Product Change Notification (PCN)

PCN Number	507428	Date Issued	August 16, 2019
Reason for Change	Change to Product		
Change Type Description	This letter is to inform you that changes are being made to the part(s) identified in this Notice. The change may affect the fit, form, function or appearance of the parts, or it may result in a change to the specification. The pictures below show an example of the possible differences.		
Reason for Short Notice	Corrective Actions		
Assessment of Change	Passed FAI		
Internal Molex Qualification Date	September 30, 2019		
Sample Availability Date (Changed Part)	September 30, 2019		
Planned Implementation Date	October 15, 2019		
Method of Identifying Change	Special label on the packaging

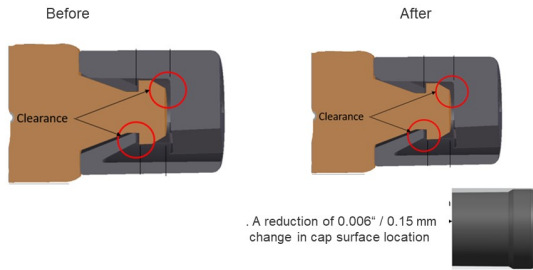
- Enhancement was made to provide a more secure latch between the caps latching features and post head feature, a reduction of 0.006" is being done to the latch.
- Product Impact
Change impact the fit of the part, improving the retention.
- Part Number Impact
— See attached list
- Qualification Reports and samples available upon request after the date shown above.
